Technical Service Bulletin

SUBJECT:			No: TSB-15-13-001REV
ENGINE STALL/PCV HOSE DISCONNECTION (LOW ENGINE SPEED, HIGH AMBIENT TEMPERATURE)			DATE: July, 2015
			MODEL: 2014-15 Mirage
CIRCULATE TO:	<input type="checkbox"/> GENERAL MANAGER	<input type="checkbox"/> PARTS MANAGER	<input checked="" type="checkbox"/> TECHNICIAN
<input checked="" type="checkbox"/> SERVICE ADVISOR	<input checked="" type="checkbox"/> SERVICE MANAGER	<input checked="" type="checkbox"/> WARRANTY PROCESSOR	<input type="checkbox"/> SALES MANAGER

This bulletin supercedes TSB-15-13-001, issued March, 2015, to add PCV hose disconnection details. Revisions are italicized and indicated by ◀.

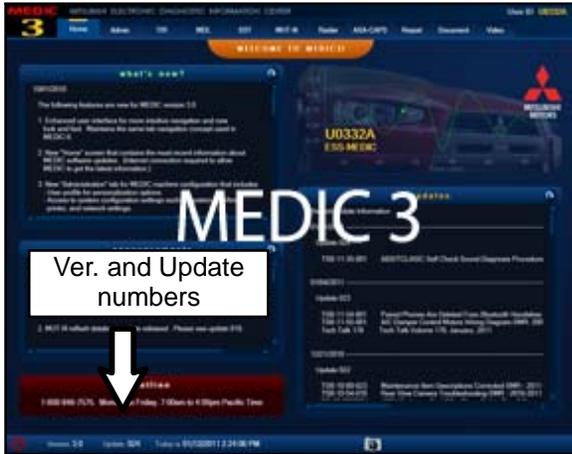
1. If the PCV hose is detached at either end (usually at intake manifold end), and is not damaged, reconnect it (red hose in illustration). Only replace the hose if it is damaged.
